# Replace Front Drive Unit to HVJB Harness

<b>Classification</b>	Campaign Bulletin	<b>Section/Group</b>	44 - High Voltage System	<b>Country/Region</b>	All
<b>Year</b>	2014	<b>Model</b>	Model S	<b>Version</b>	Dual Motor

Figure 1

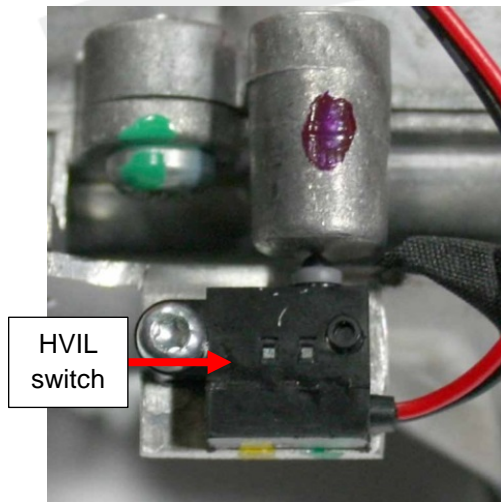
- If there is an HVIL switch (Figure 1) connected to a 12V HVIL connector (Figure 2), no additional work is required. Reinstall the 2<sup>nd</sup> row seat base frame and discontinue this procedure.
- If the fuse does not have an HVIL switch, continue this procedure.

Figure 2

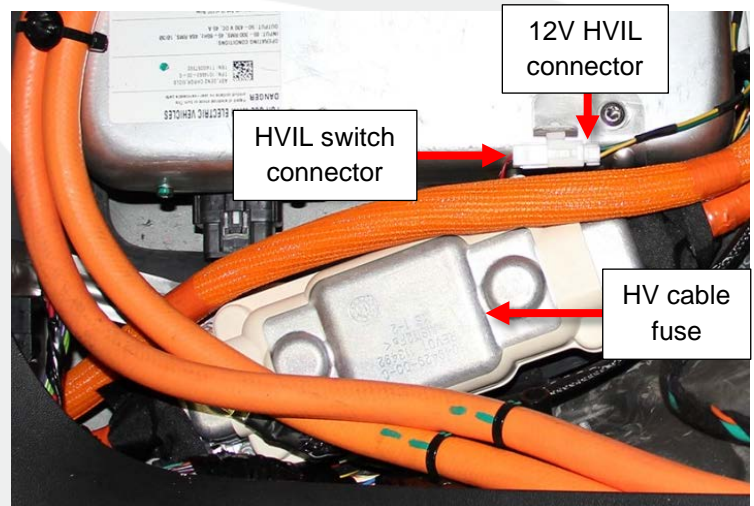
**NOTE:** If the vehicle does not have a 12V HVIL connector, contact Service Engineering.
